PROPOSED WAITING RESTRICTIONS – BEVAN CLOSE, DEAL

Summary: **This report gives details of the proposed waiting restrictions to be introduced in Bevan Close, Deal under a Section 106 agreement.**

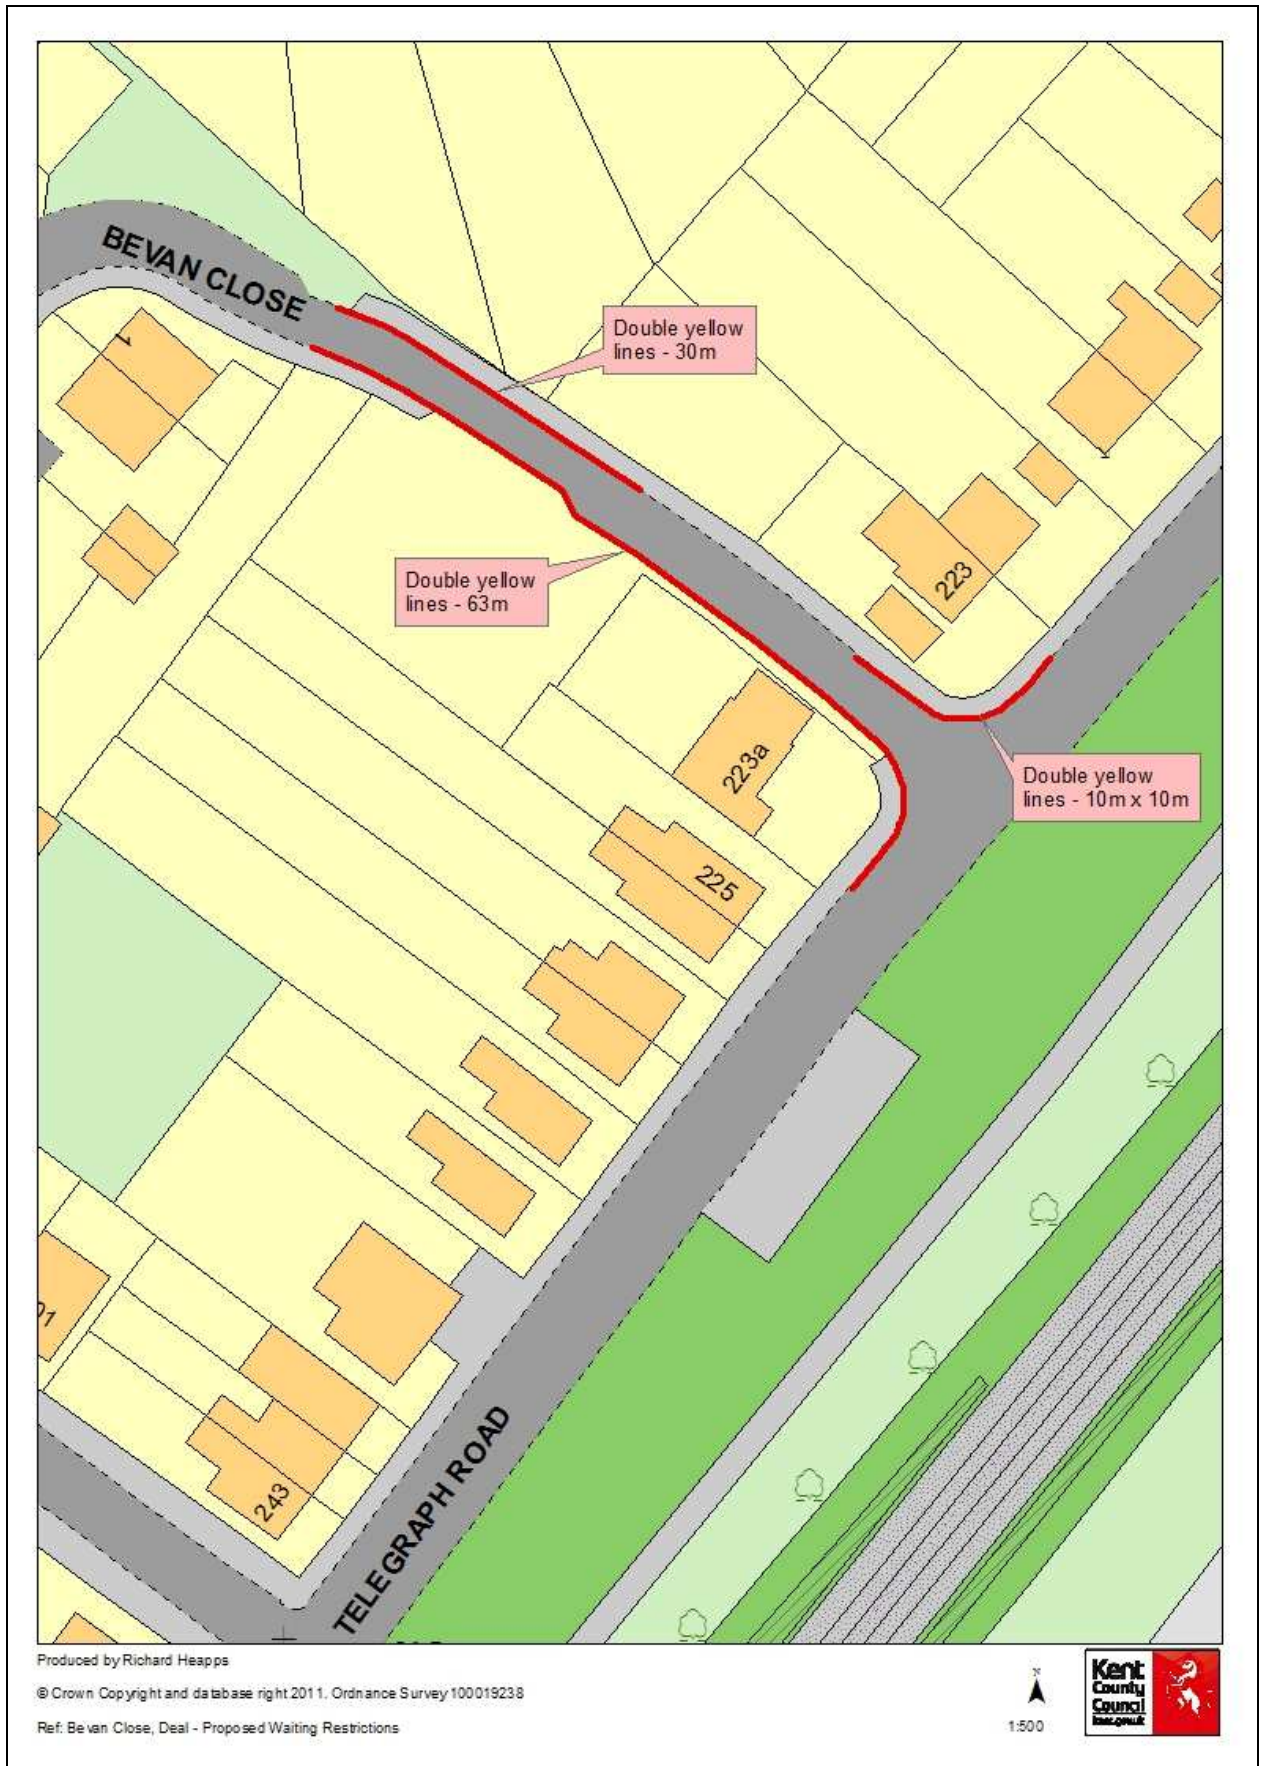
2.1 Following the advertisement of the revised proposals, a number of comments and objections have been received regarding the proposal. These are summarised in the table below:

Name	Support/object	Comment	KCC response
Kent Police	n/a	No specific observations to make.	
Resident, Bevan Close	Support	<ul style="list-style-type: none"> • Cars parked at junction obstruct view. • Parked vehicles in the close forces cars on to wrong side of road on approach to junction. • Restrictions may displace parking to other, more obstructive areas of the close. • Suggests residents parking. 	<ul style="list-style-type: none"> • Proposal would help improve sightlines and increase road space. • Proposal could cause parking displacement. • Dover District Council would not consider an isolated Resident Parking Scheme here.
Resident, Bevan Close	Support in part	<ul style="list-style-type: none"> • Concerned about displaced parking. • New houses are being built, and worried about where visitors to these properties will be able to park 	<ul style="list-style-type: none"> • Proposal could cause parking displacement. • Parking in the area is quite scarce.

Resident, Bevan Close	No opinion given	<ul style="list-style-type: none"> • Concerned about parking being displaced. 	<ul style="list-style-type: none"> • Proposal could cause parking displacement.
Resident, Telegraph Road	Object	<ul style="list-style-type: none"> • There are no safety concerns as this is the widest part of the road. • Will displace parking to the cul-de-sac end of the road. • Only area of questionable safety is the narrow part by the bend at the end of the road, as cars parking there force passing vehicles on to opposite side of the road on a blind bend. 	<ul style="list-style-type: none"> • Proposal could cause parking displacement. • No proposals made for top end of road.
Resident, Telegraph Road	Object	<ul style="list-style-type: none"> • Vehicles do not park in narrow section of road. • Vehicle parked in straight section of road does not block the road. • Restrictions will displace parking in to Telegraph Road where parking is already restricted. 	<ul style="list-style-type: none"> • Proposal could cause parking displacement. • Vehicles parked in straight section of road do leave sufficient room for many vehicles to pass, but evidence of larger vehicles riding up on the verge (tracks in

2.3 Further to the response received, a petition was also submitted, objecting to the proposal on the basis that it will displace parking to the cul-de-sac end of Bevan Close and in to Telegraph Road. There are 19 signatories from Bevan Close and Telegraph Road.

3.1 Based on the responses received, and the comments made, Members are asked to agree to implement the waiting restrictions only at the junction of Telegraph Road and Bevan Close, for a distance of 10m in each direction, as given in Section 243 of the Highway Code. A plan is shown in Appendix C.

Appendix A – Proposed Waiting Restrictions (Original Proposal)

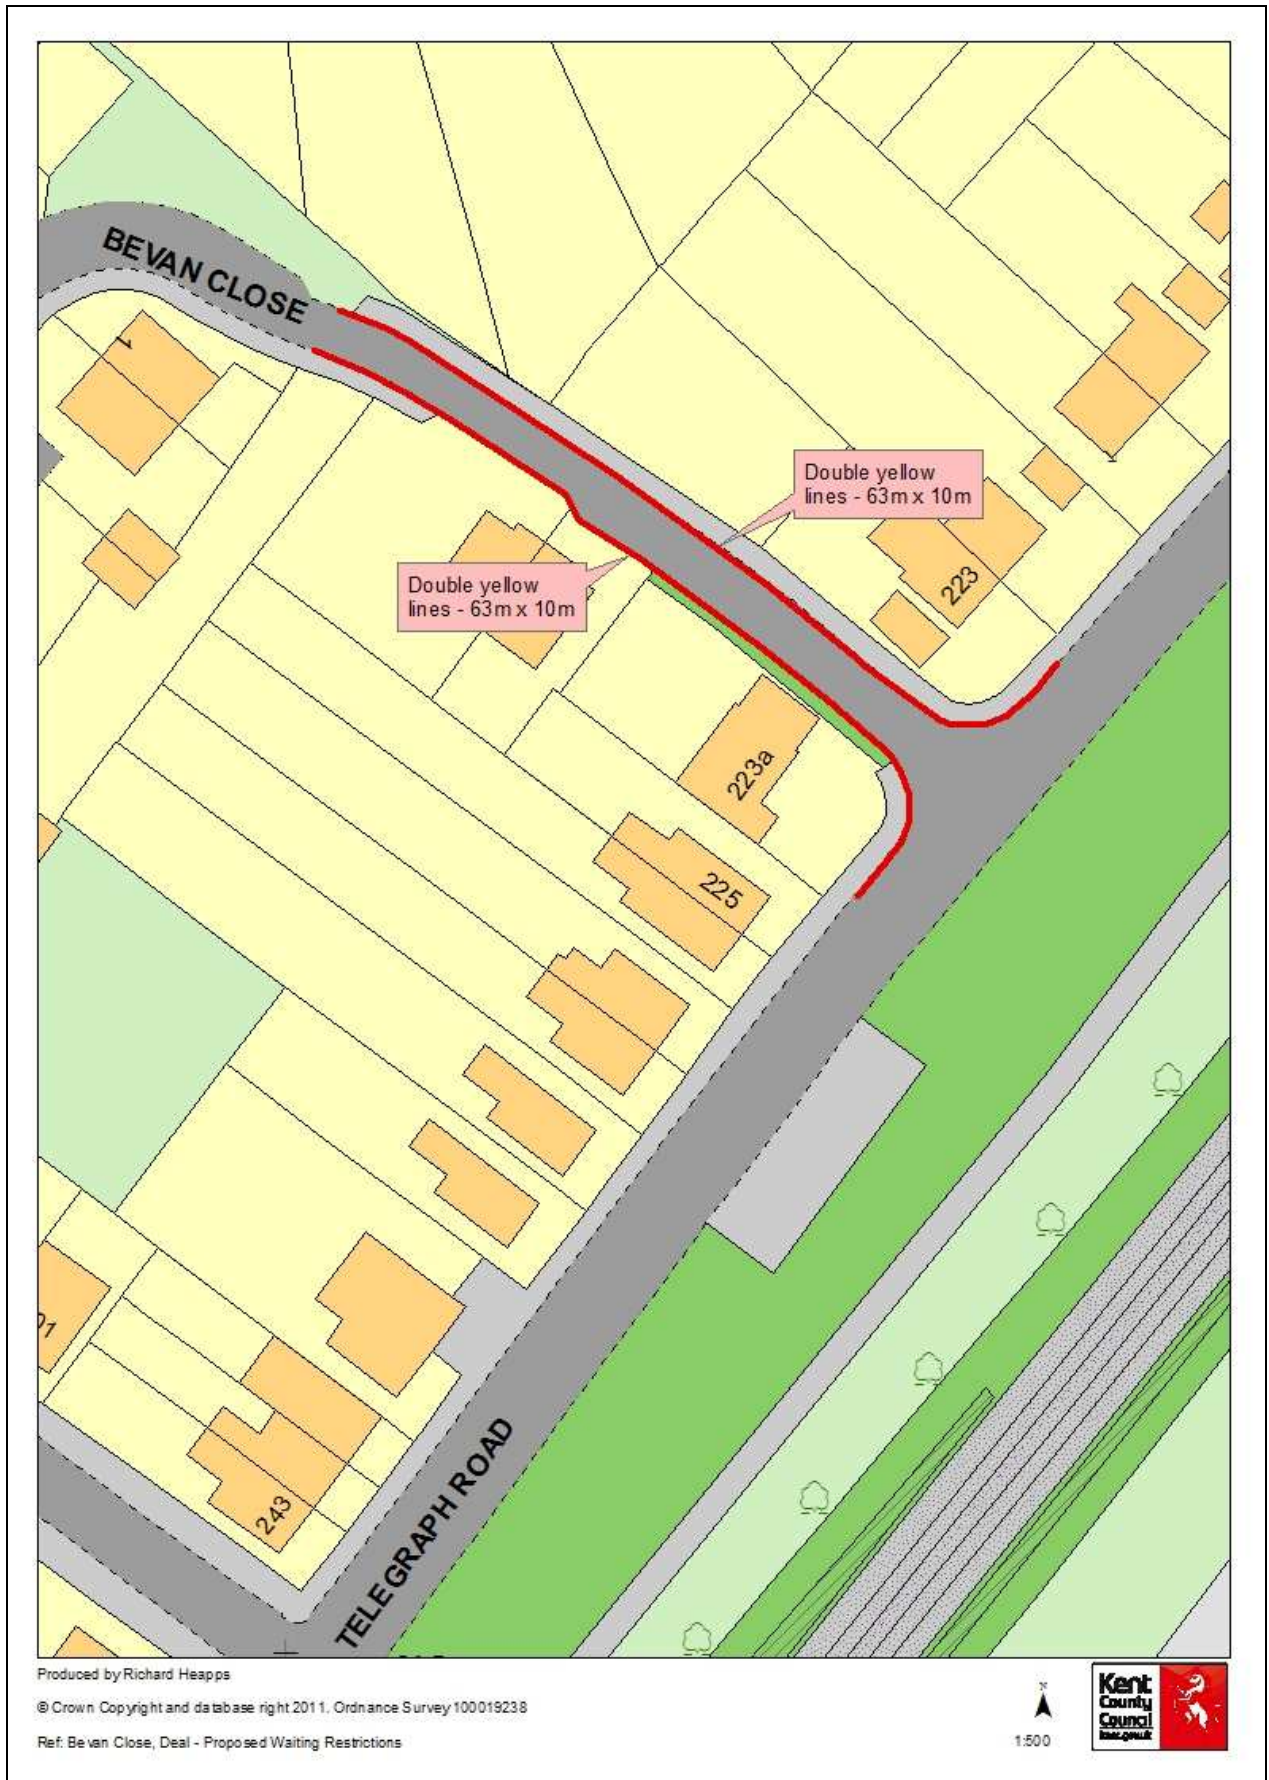
- 1.5 A break in the restrictions was included, to allow for some parking between the junction with Telegraph Road and where the road narrowing is.
- 1.6 The proposal was advertised in Kent on Sunday, through on-street notices, and through a letter drop to local residents and stakeholders. One letter of objection was received from Deal Town Council. No other comments were received.

- 1.7 A report was submitted to the Dover Joint Transportation Board on 12 December 2013. Following representations by a representative from Deal Town Council, it was agreed to meet on site to discuss the proposals. It was agreed to re-advertise the Traffic Regulation Order, with a small break in the line removed.

- 1.8 A plan of the original proposal and the new proposal can be found in Appendix A and Appendix B respectively.
